This document is the response of the authors to the reviewers comments. It includes a point-by-point response to the reviews and a marked-up manuscript version

Climate Change Impacts on Yangtze River Discharge at the Three Gorges Dam

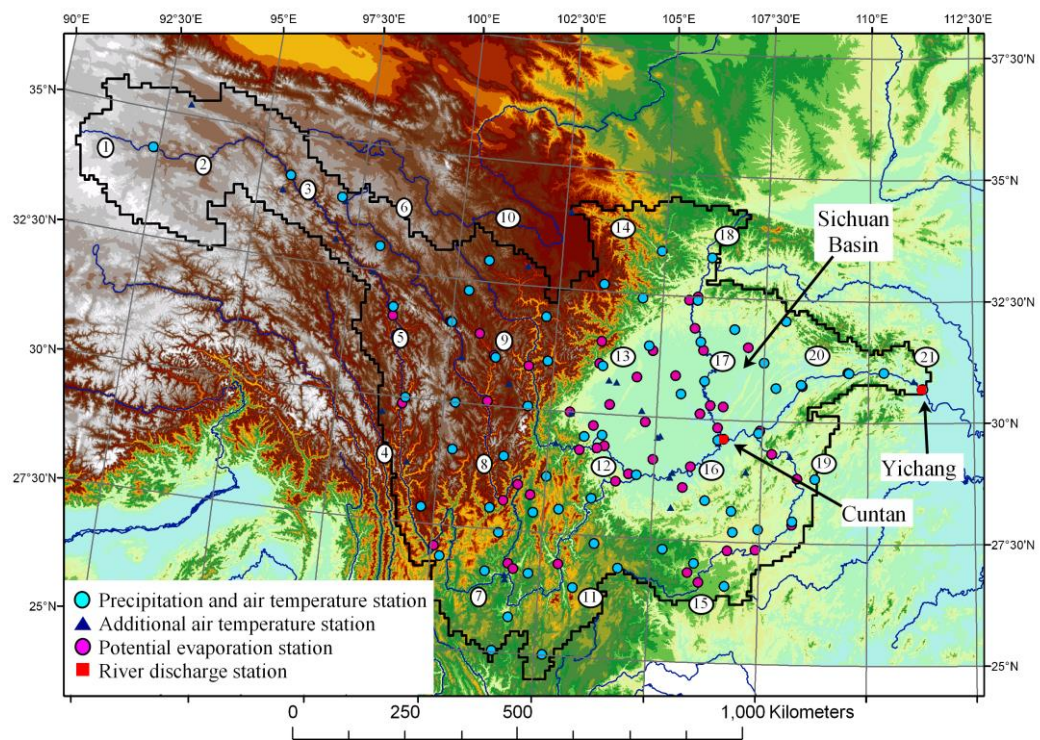
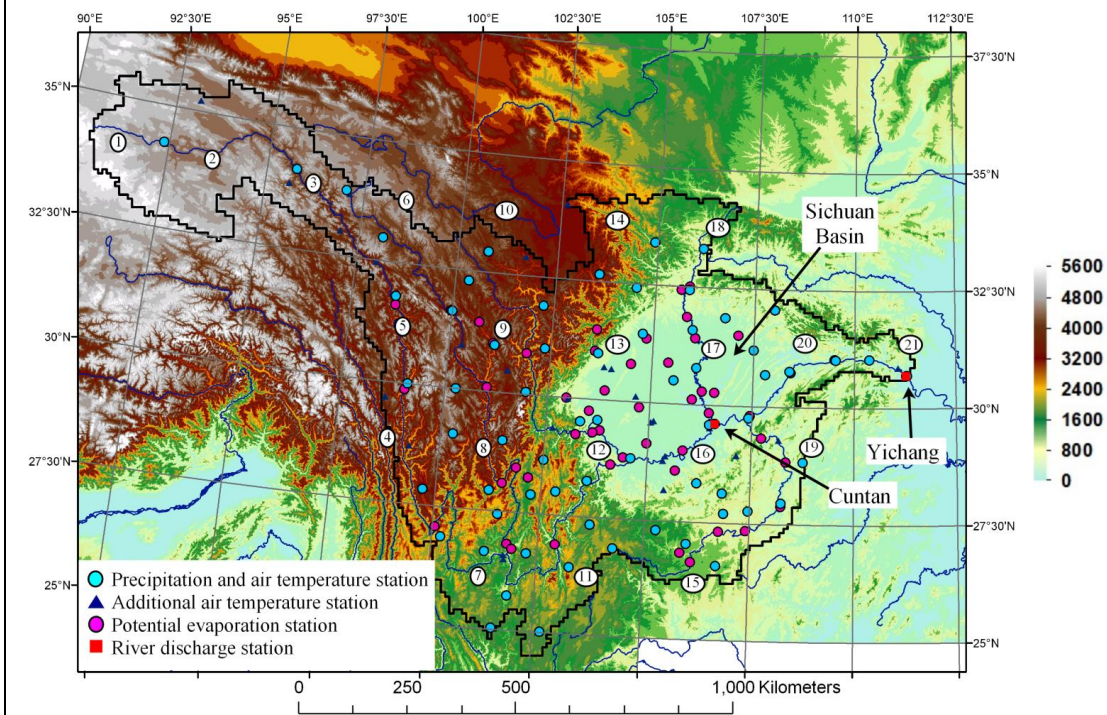
Minor comments 12. *“Figure 1: Please add a color bar showing elevation”*

Authors Response: As suggested we have added a colour bar showing elevation.

Figure 5. Simulated Snow water equivalent depths (mm) at the end of the months from December to May for the current climate and two future climate models.

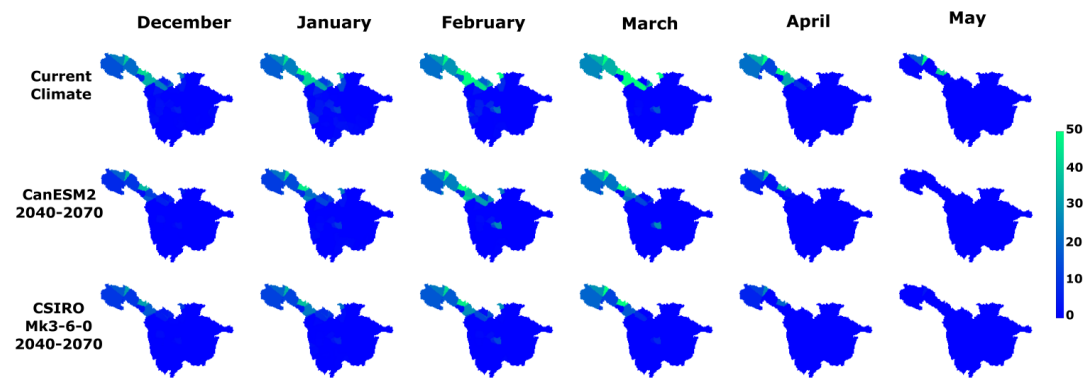
Major comment 2. “Snow. ... More generally, it suggest that the authors plot the annual cycle of SWE (monthly means) under current and future climate, and discuss to which extent the snow pack influences current and future discharge.”

Authors Response: As suggested by the referee we have added an additional Figure of the annual cycle of SWE under the current climate and for two GCMs (CanESM2 and CSIRO Mk3-6-0) under a future climate. The effect of snow under the current climate has been considered in more detail with the following added to the text in Section 3.1

“Figure 5 shows that by the end of May under the present climate there is still a significant amount of snow in the upper part of the basin whereas for CanESM2 and CSIRO-Mk3-6-0 (+12.7 and -3.7% change in precipitation, respectively) all the remaining snow melts in May (note that there is a travel time of approximately 30 days for the water to flow from the upper part of the basin to Yichang).”

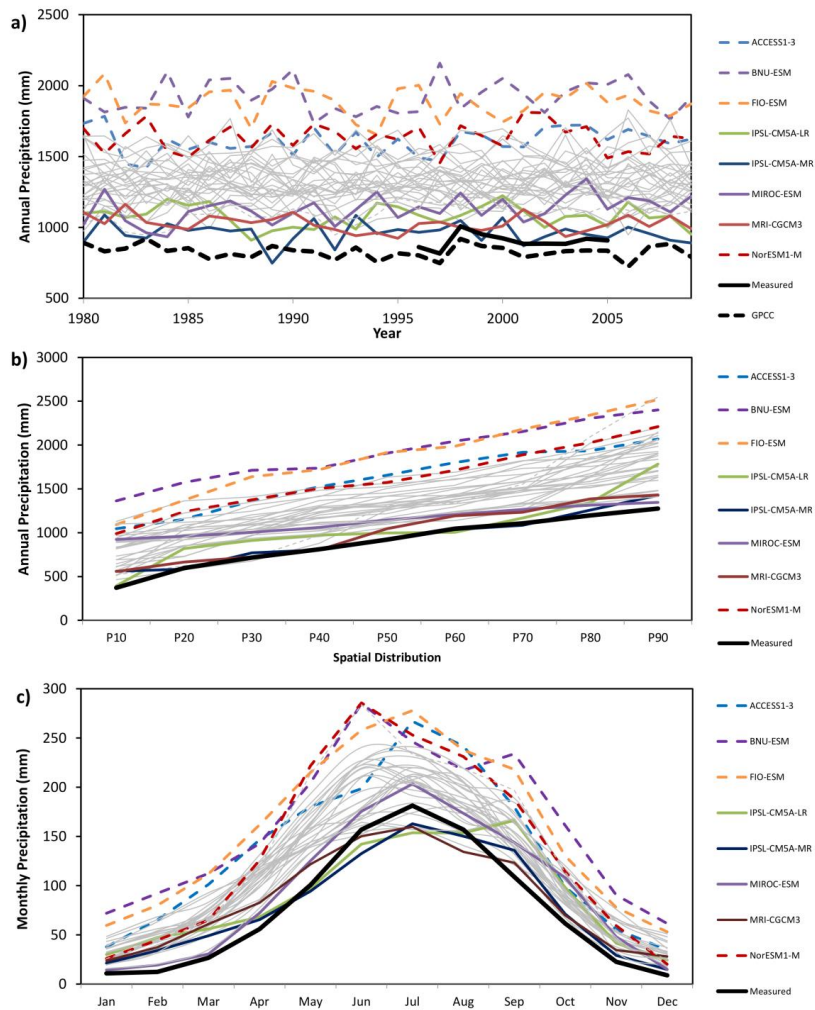
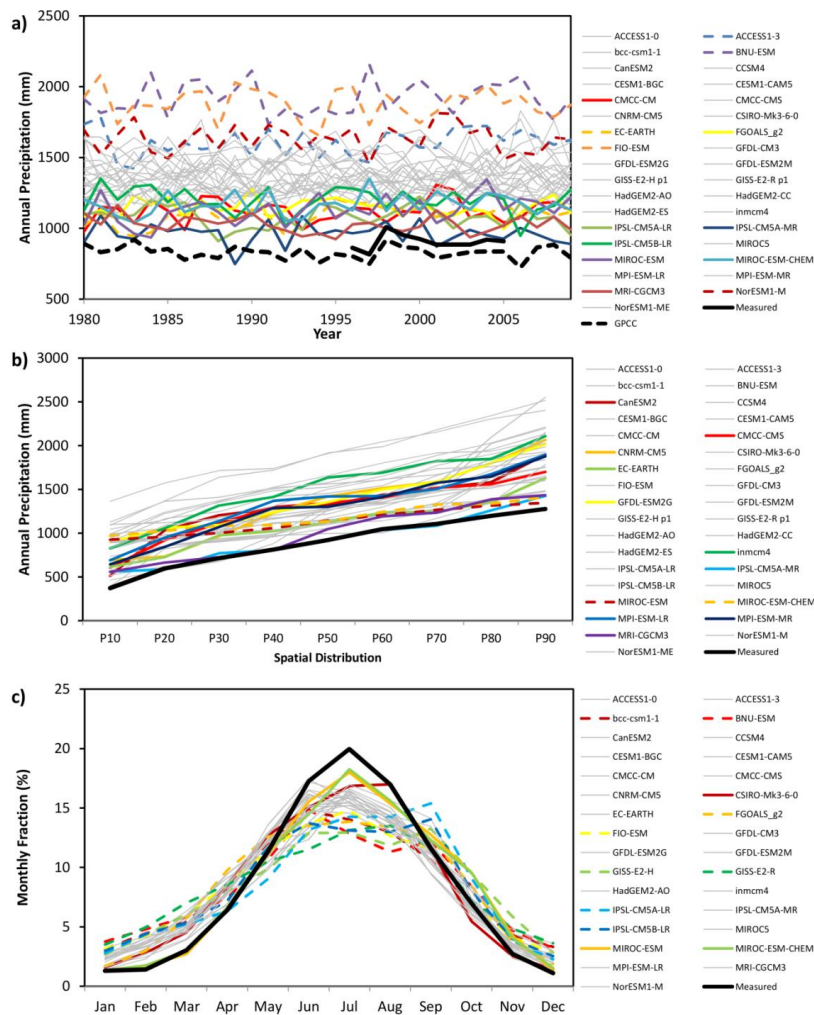
Minor comments 13. *“Figure 5: Why are some models represented by a colored line and others by a gray line? I am guessing from the caption of Figure 10 that grey models do not have lateral boundary conditions available. Please amend the caption. Figure 5c: Why did the authors decide to depict the monthly fraction and not the monthly amounts? Without the monthly amounts it is hard to tell how well the GCMs are doing in absolute term”*

Authors Response: If all the GCMs in Figure 5 (now Figure 6) were coloured it is impossible to distinguish which line is associated with which model. So only the best and the worst models are coloured (this is now done in a consistent way). We have amended the caption to make this clear.

We could not decide if monthly totals or monthly fractions was the better way of showing this data. As suggested by the referee we have changed this to monthly totals.

Figure 7. Comparison of the measured and CMIP5 climate models for the temperature in the Yangtze basin. The data from each GCM is shown but only the three with the largest and smallest totals are in colour the rest are shown in grey. (a) Annual precipitation (b) Spatial

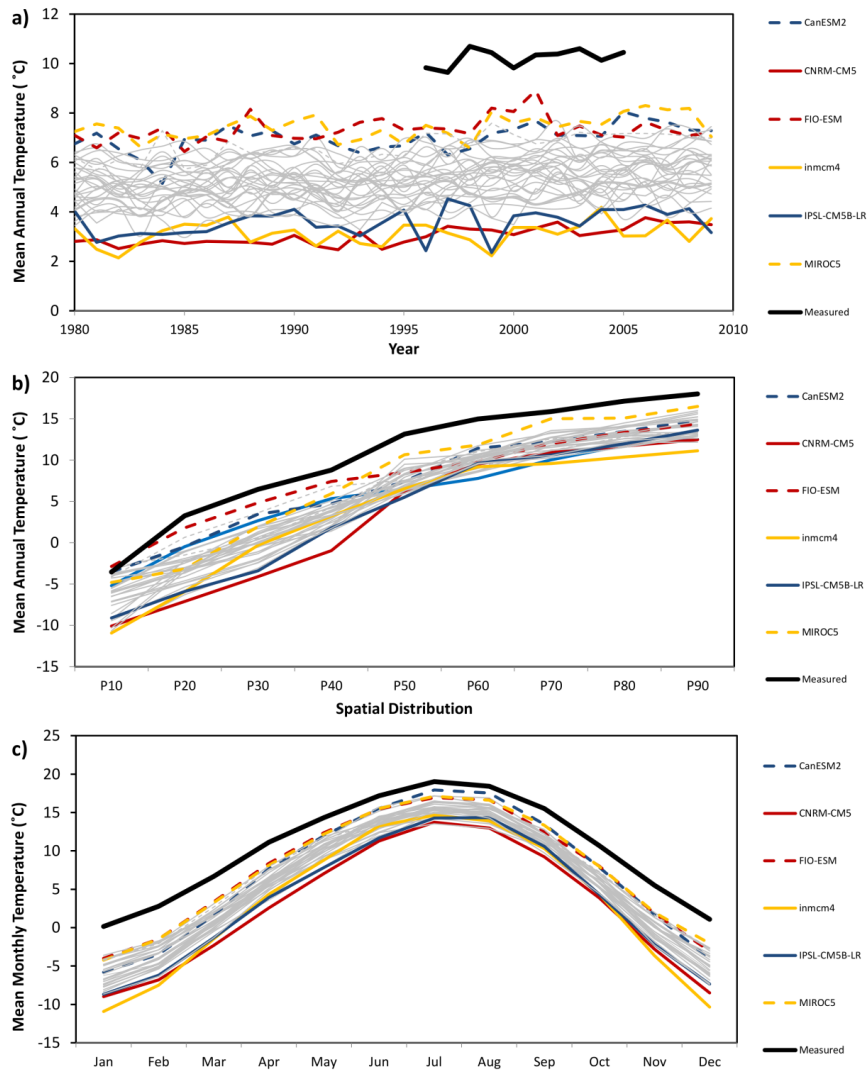
Minor comments 11. *“Tables 3 and 4: Overall, I find that tables of numbers, like Tables 3 and 4 are difficult to interpret. I suggest replacing them by a graphical representation of the same content. Or at least producing a Figure similar to Figure 5 but for temperature”*

Authors Response: As suggested we have added a figure similar to Figure 5 but for temperature. (Figure 5 is now called Figure 6 and there is a new Figure 7)

Figure 86. Box plots showing monthly changes between 1981-2010 and 2041-2070 in precipitation, temperature and potential evaporation for the 78 CMIP5 runs averaged over the Yangtze basin.

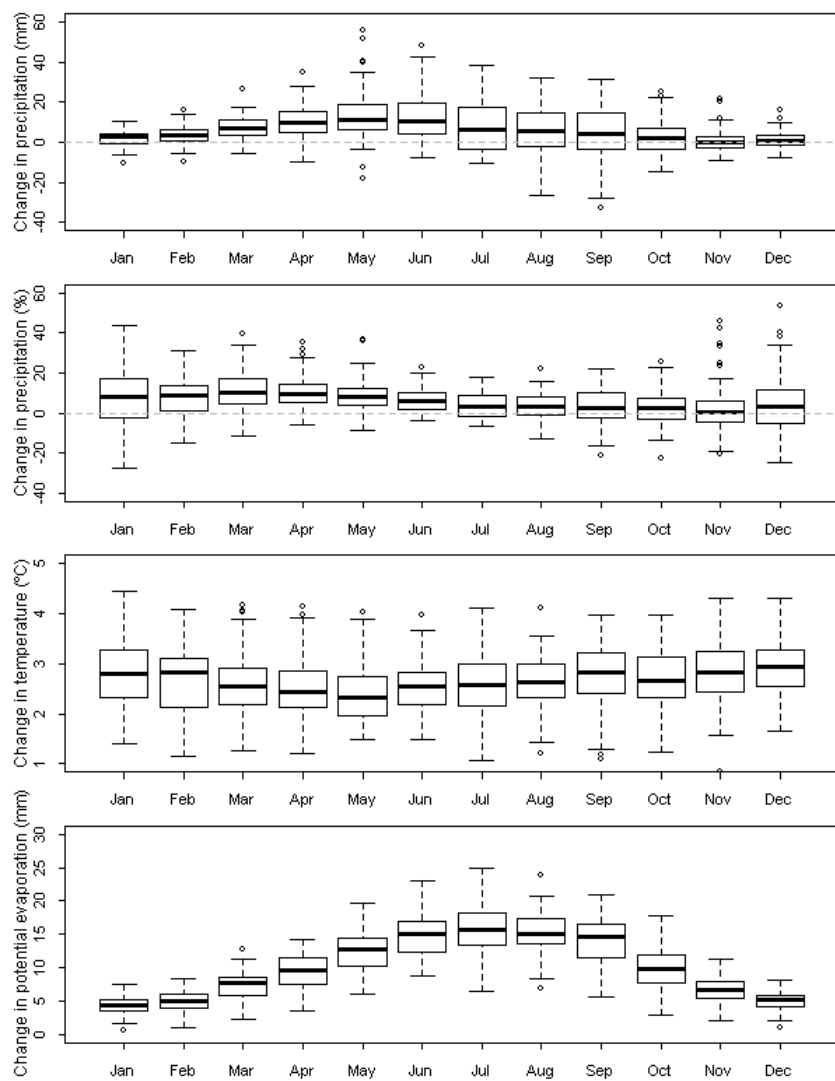
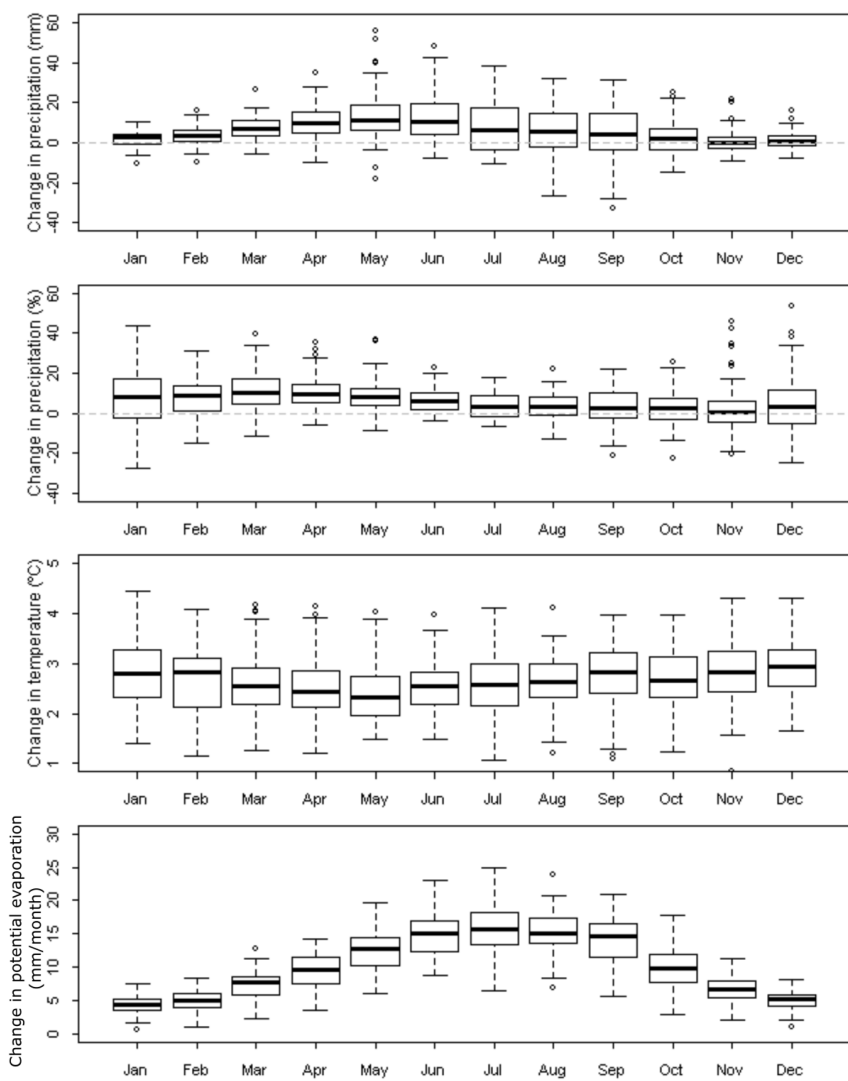
Minor comments 14. *“Figure 6: mm/month instead of mm?”*

Authors Response: As suggested by the referee we have changed the title.

Figure 97. Box plots showing spatial changes between 1981-2010 and 2041-2070 in precipitation, temperature and potential evaporation for the 78 CMIP5 runs. The numbers on the x-axis correspond to the 2.5° by 2.5° CMIP5 grids numbered in the Fig 1. [and shown in the inset.](#)

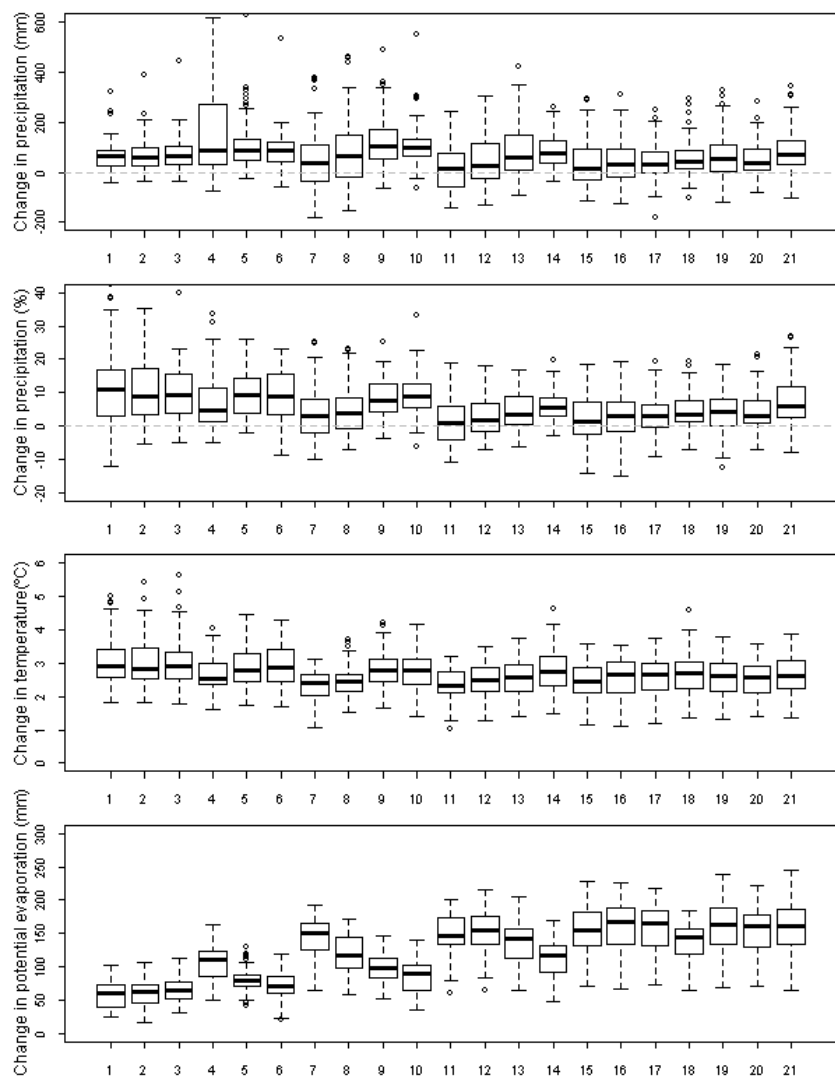
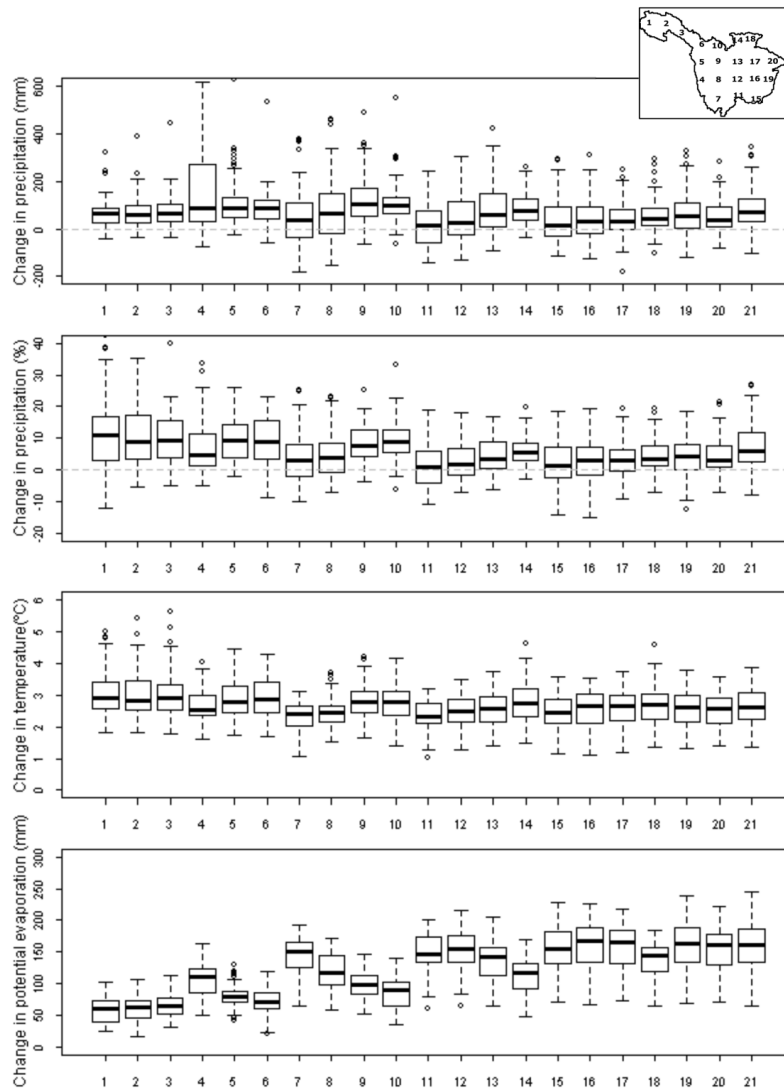
Minor comments 15. *“Figure 7: Would it be possible to replace this Figure by a map, with for instance the color of the grid cells indicating the mean change, and the hatching density indicating the agreement between the different models? Or at least add some kind of information on the location of these grid points, for instance “south-west”, etc”*

Authors Response: We have added an inset map to the figure showing where in the Yangtze basin the numbers on the x-axis refer to. We feel this makes it much easier to interpret. The reason we did not substitute the boxplots for a map was because we wanted the full range of projected changes to be visible.

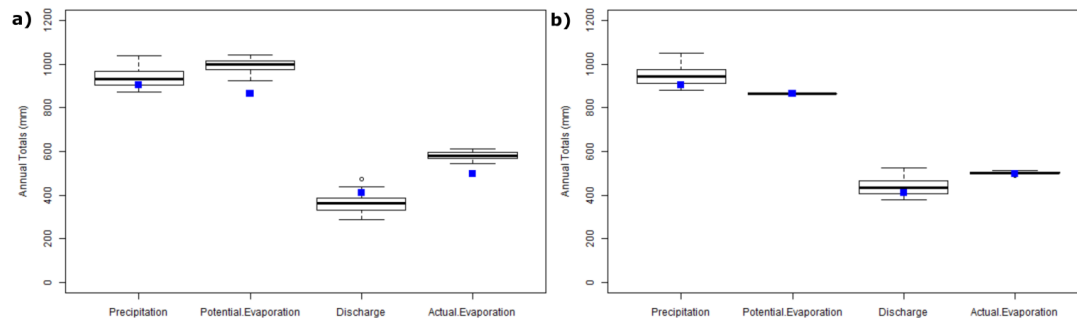
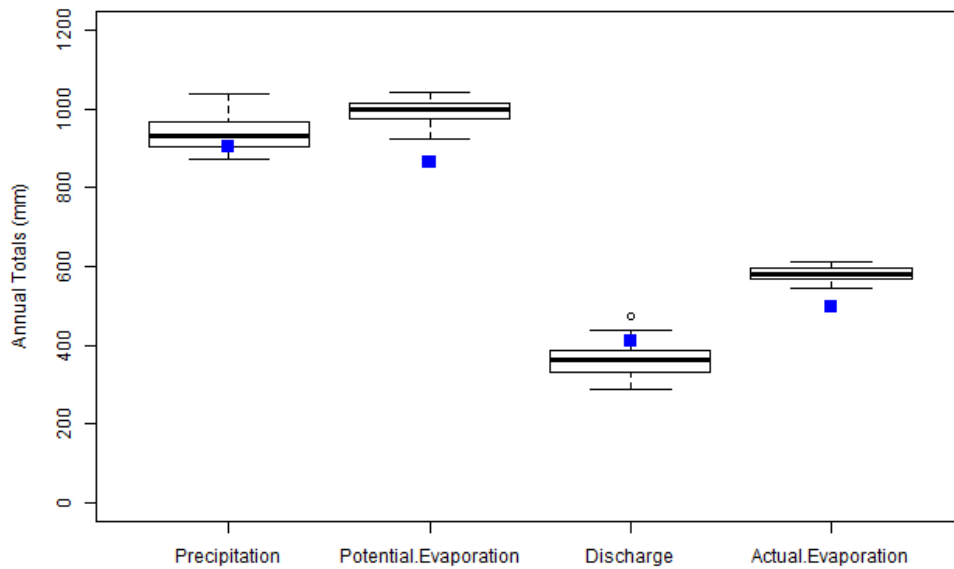
Major comment 1. “Evapotranspiration.I suggest that: 1) the author examine whether there is any trend in the observations from the 52 PET stations (ideally over a period longer than 10 years) and 2) the authors extract the ET simulated by the climate models, and assess whether there is a increase in ET, as those simulations can be considered as more reliable than Thornthwaite approximations (Milly and Dunne, 2016). Maybe add a plot to Figure 6 showing ET as simulated by the GCMs and as simulated by Shetran, and add boxplot to Figure 8 showing future ET if PET is held constant. This would illustrate the sensitivity of the projections to the formulation of PET”

Minor comments 16. *“Figure 8: The second sentence of the caption should probably be “The blue squares show the values for the present climate”, like in the text. But then, which of these values are measured and which are modeled?”*

Authors Response: There is insufficient data (only 10 years) to look at trends in the 52 PET stations. As the referee suggests we have extracted the ET values from the 78 climate model projections (35 different GCMs) for the current (1981-2010) and future climates (2041-2070). Averaged over the entire Yangtze basin these show an 8.4% increase compared to a 17% increase using the Thornthwaite equation. The following has been added to the text “Further analysis was carried out by considering the change in actual evaporation from the 78 climate model projections. Averaged over the Yangtze basin this shows an increase of 8.4% under the future climate compared to a 17% increase in actual evaporation using the PET calculated from the Thornthwaite equation and a 1% increase in actual evaporation with no change in PET. This suggests the future actual evaporation might be between the two extremes shown in Fig 10a and Fig10b.” As suggested by the referee we have added another Box plot to Figure 10 (previously Figure 8) showing future ET if the PET is held constant.

Authors Response: As suggested by the referee we have changed the text in the Figure so it says “The blue squares show the simulated values for the present climate.”
